MANDATORY

SERVICE BULLETIN

Service Bulletin No. 366C
(Supersedes Service Bulletin No. 366B)
Engineering Aspects are
FAA Approved

SUBJECT: Carburetor Throttle Body Screw Inspection

Figure 1
Illustrative Example of Throttle Body Attaching Screws

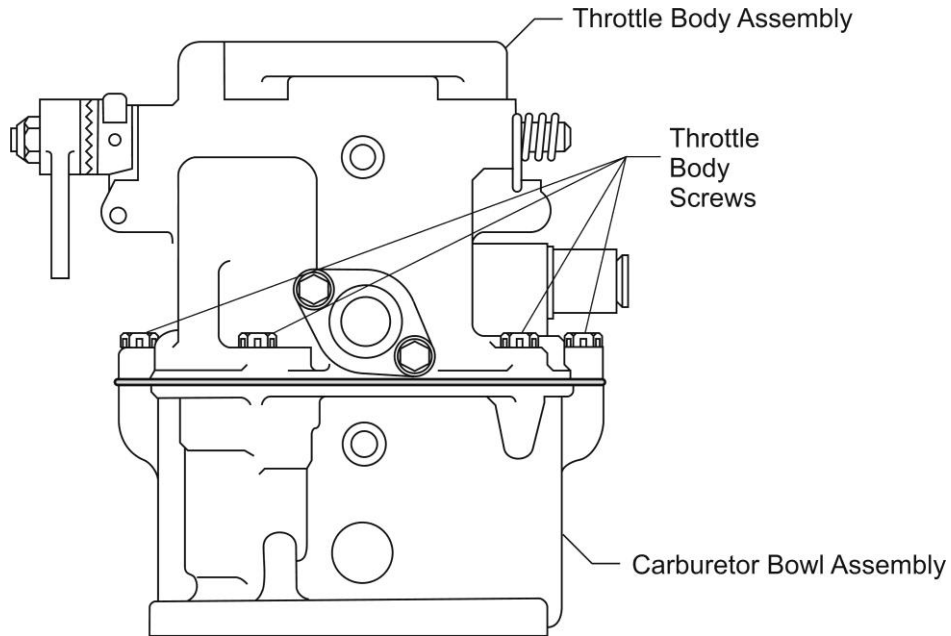
See Figure 1 for illustrative example of the throttle body attaching screws.

1. Examine the carburetor for evidence of fuel stains on the outside of the bowl along the parting line.
2. Complete a check for movement between the throttle body and bowl.
3. Make sure each throttle body-to-bowl attaching screw is secure and not loose by attempting to move the screw and/or locktab washers with your fingers.

CAUTION: IF ANY ATTACHING SCREW IS LOOSE, DO NOT ATTEMPT TO TURN THE SCREW WITH A SCREWDRIVER. IF YOU TURN THE SCREW WITH A SCREWDRIVER, IT COULD DAMAGE THE LOCK WASHERS AND INCREASE THE LIKELIHOOD THAT THE SCREWS WILL BECOME LOOSE.

Models MA-3A, MA-3PA, MA-3SPA, and MA-4SPA have four screws. Models MA-4-5, MA-4-5AA, and MA-6AA have six screws.

4. If there is evidence of fuel stains, movement between the throttle body and bowl, or the throttle body-to-bowl attaching screws are loose then remove the carburetor in accordance with the applicable engine and airframe service manuals. Send the carburetor to a qualified repair station for troubleshooting and repair. Reinstall the carburetor in accordance with the applicable engine and airframe service manuals.
5. Make an appropriate logbook entry showing compliance with this Service Bulletin.
